PLANNING, ZONING, & BUILDING DEPARTMENT
PZ&B Staff Combination Memorandum: Architectural Commission and Town Council

SUBJECT: ARC-24-0085 (ZON-24-0044) 315 CHAPEL HILL RD

MEETING: NOVEMBER 22, 2024 ARCOM
DECEMBER 11, 2024 TC

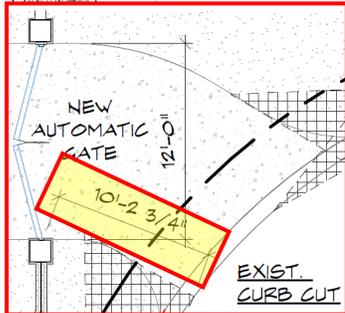
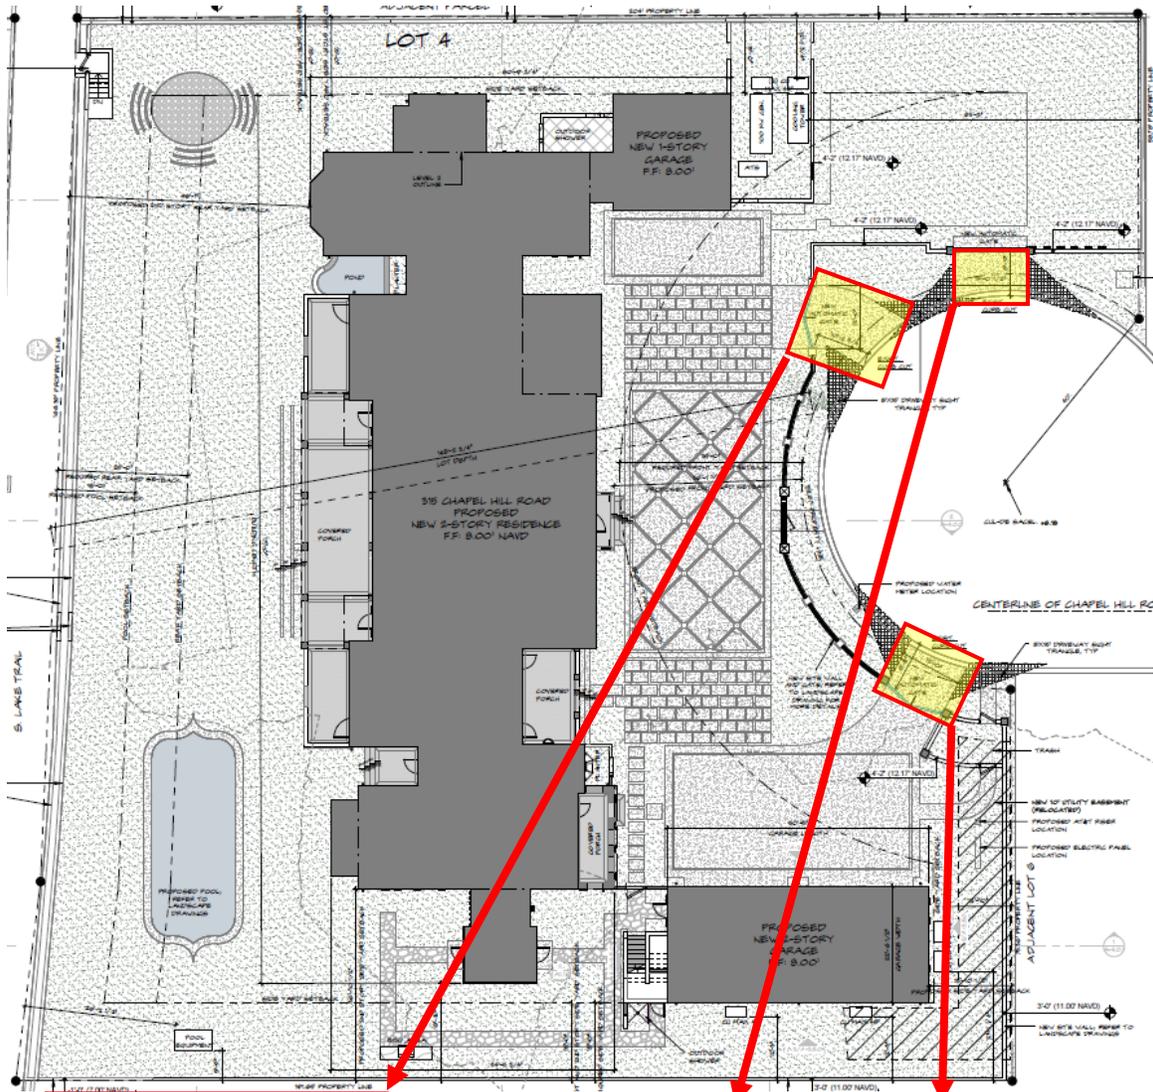
The proposed gates do require review and approval by Town Council. **Special Exception # 2** pertains to the setback distance of the vehicular gates from the Chapel Hill Road right-of-way. The zoning code requires that an 18'-0" deep vehicle queuing space be provided between the vehicle gate and the edge of the pavement to prevent a car from obstructing the roadway while waiting for the gate to operate. However, when the proposed gates are located on a cul-de-sac street, the Code

permits pursuing a special exception for reduced queuing area (in lieu of a variance as would be required on a through-street). The existing residence on site has three curb-cuts all with vehicular gates. In addition to the subject parcel, one other residence on the street has a vehicular gate.

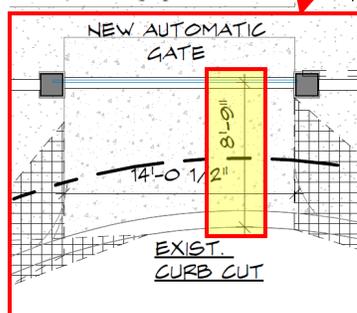
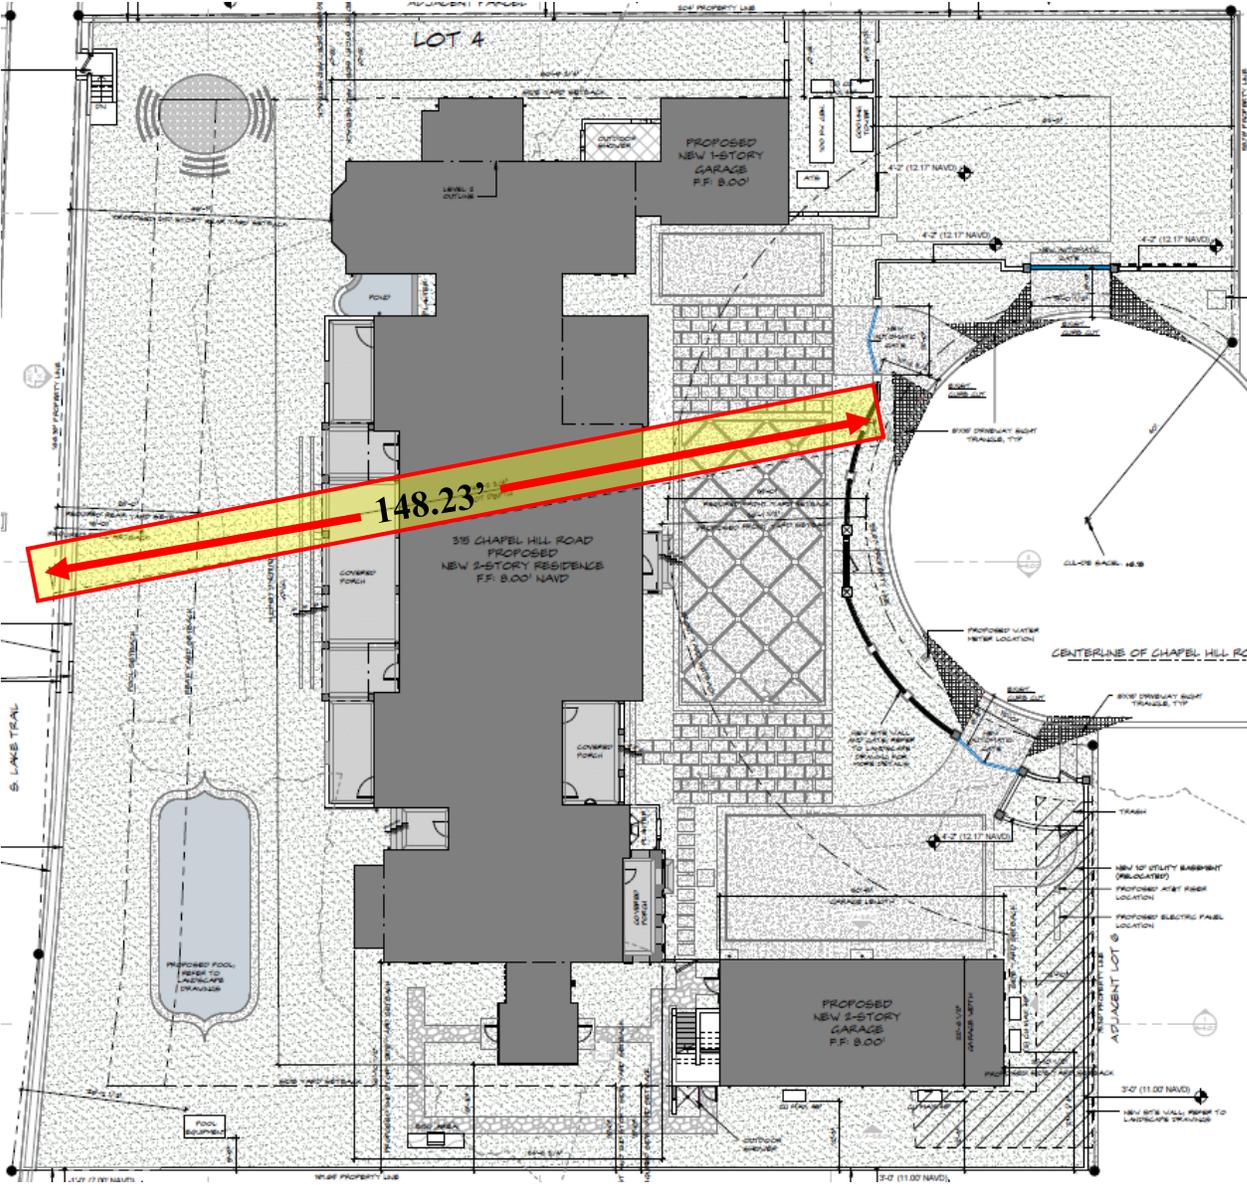
Code Section	Required	Existing/Proposed	Difference
SPECIAL EXCEPTION 2: Sec. 134-1668	18' Vehicle Loading Space at Drive Gate	10.23' (1) West Gate 8.75' (2) North-East Gate 9.5' (3) South-East Gate	-7.77' (1) West Gate -9.25' (2) North-East Gate -8.5' (3) South-East Gate

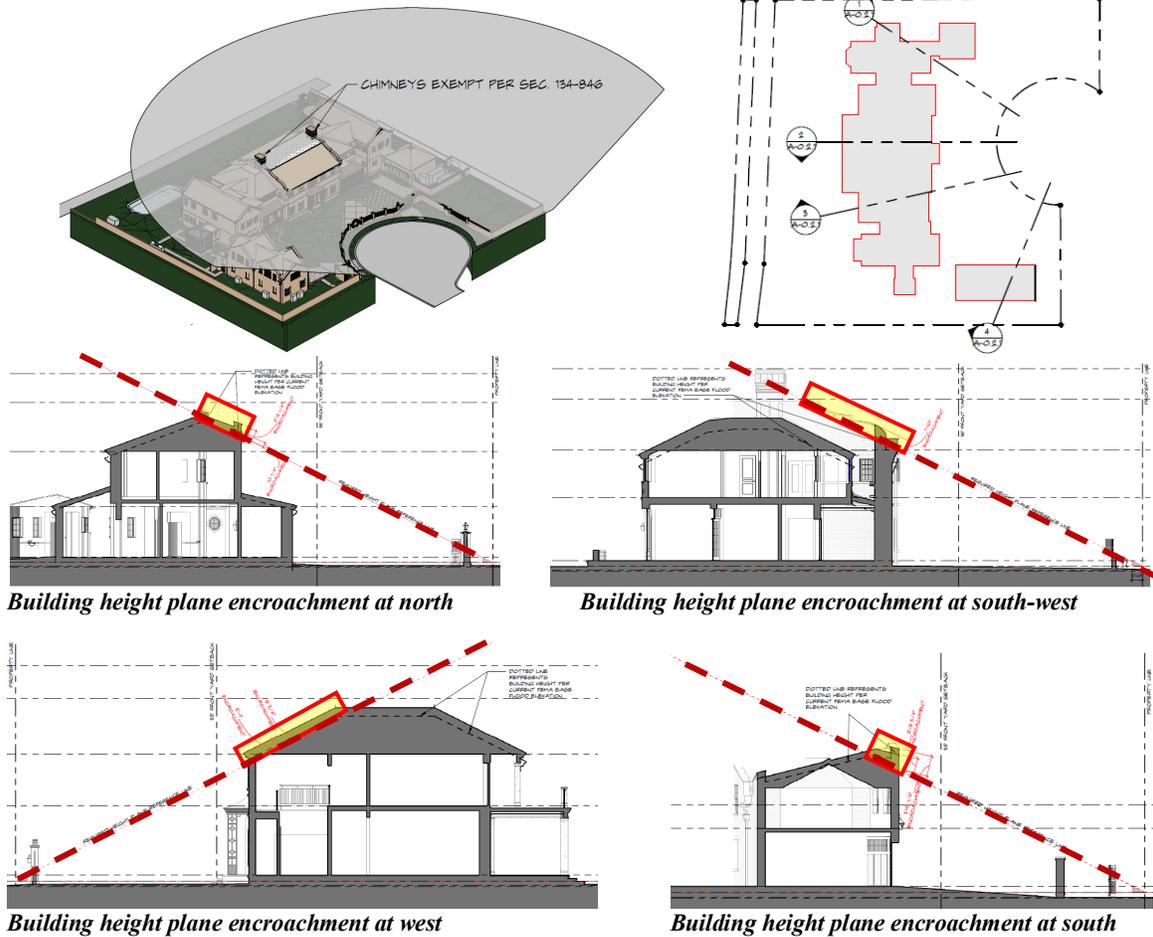
As it pertains to the **Variance** request, the applicant is proposing to construct the new residence beyond the building height plane limitation. The code states that no portion of any building or roof system shall extend beyond a height limiting plane extending at an inclined angle from the intersection of the front yard property line and zero datum. To determine the angle of the building height plane, two feet of setback are required for every one foot in building height. Due to the peculiar shape of the lot, the building projects anywhere between 0.73' to 3.44' beyond the building height plane.

Code Section	Required	Variance
VARIANCE 1: Sec. 134-843(7)	2' setback for every 1' building height	+0.73' – +3.44' Encroachment
